ADDENDUM NO. 4

October 7, 2024

**South Westnedge School Remodel & Site Improvements
3333 South Westnedge Avenue
Kalamazoo, MI 49008**

This Addendum consists of Pages ADD 4-4 and attached TowerPinkster Addendum No. 4, dated October 4, 2024, consisting of 43 pages.

UPPER LEVEL PLUMBING DEMOLITION PLAN - UNIT C
1/8" = 1'-0"

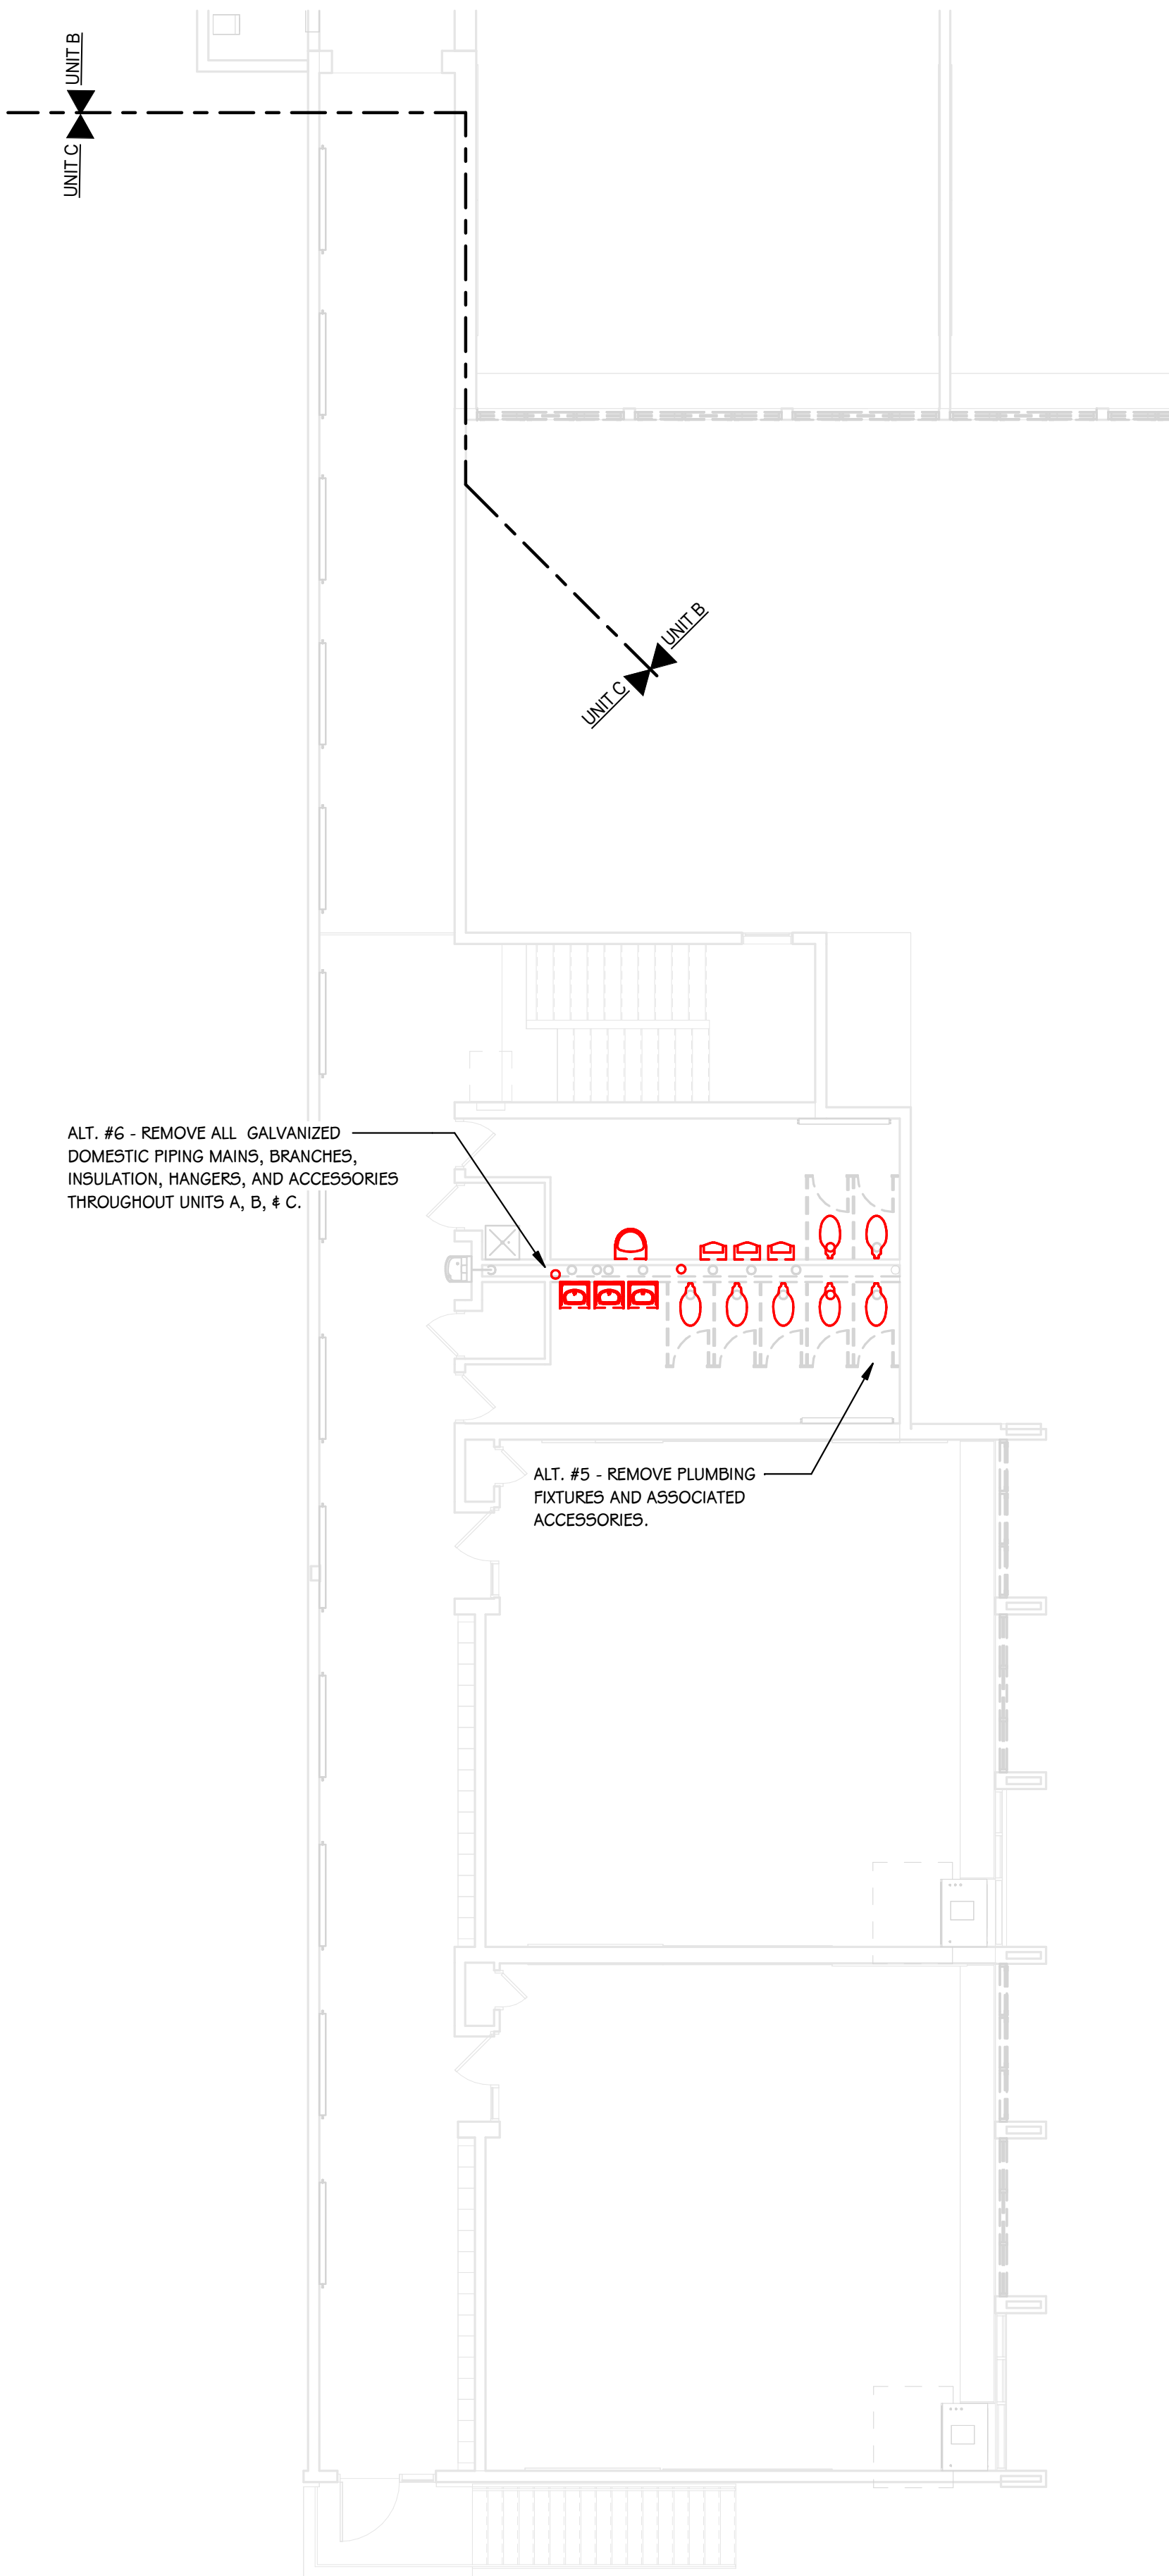
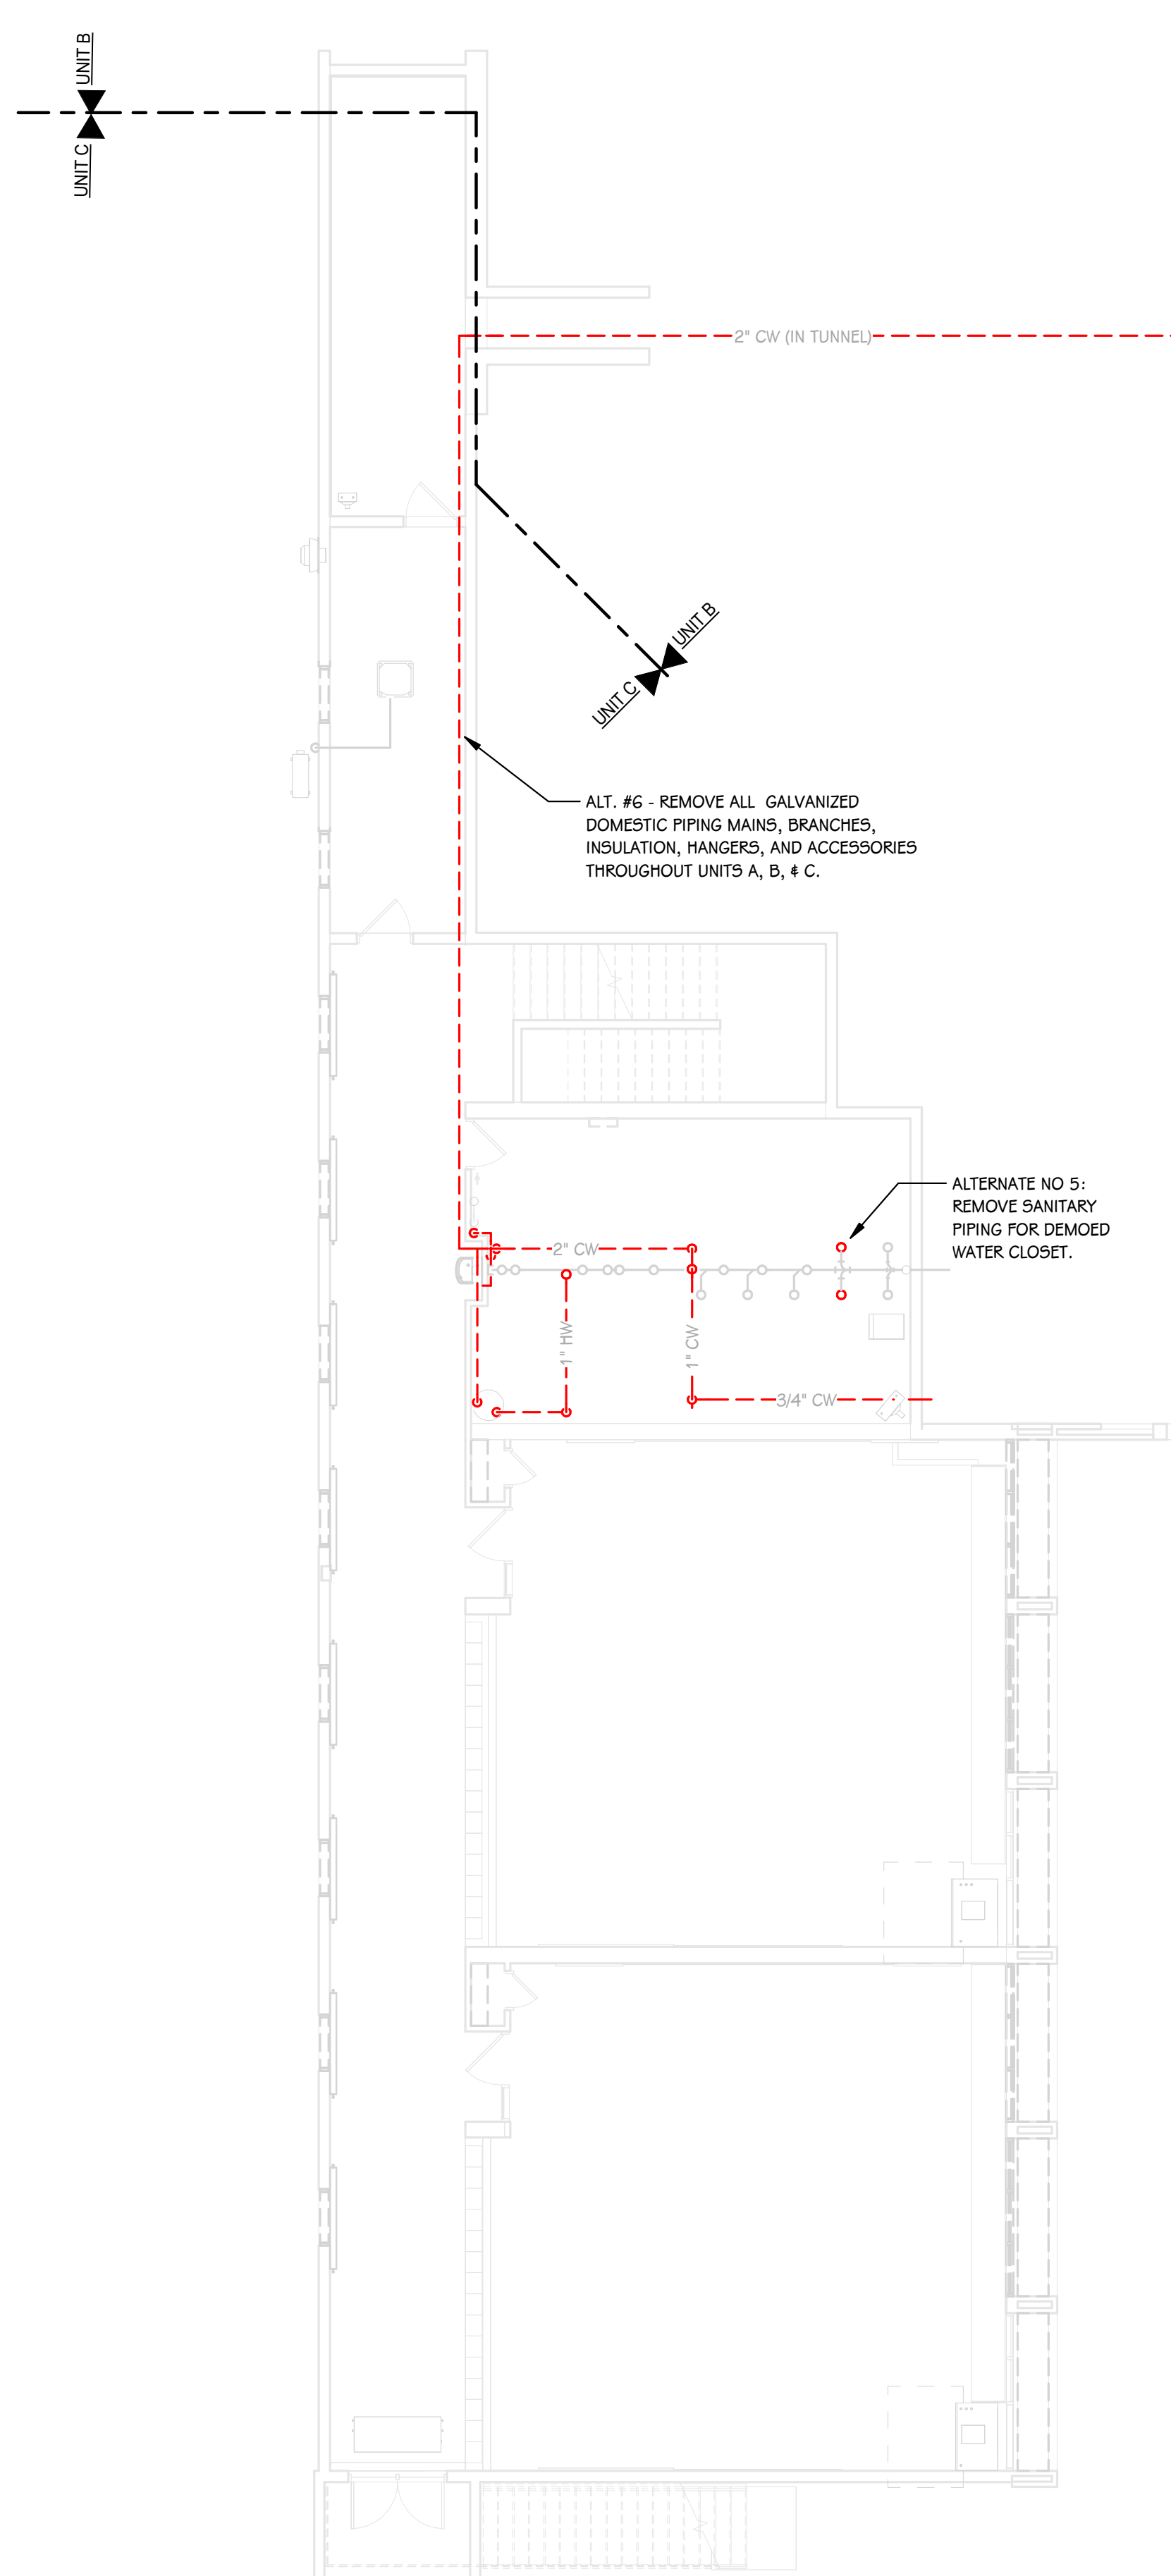
Refer to Sheet(s): P 801B, P801C, P 801D, PD 801A, PD 801B, PD 801C, PD 801D

Added demo sheets for the Alternates 5 & 6. Updated notes to provide clarity. Alternate 6 to replace all galvanized piping throughout units A, B, & C and within tunnels.
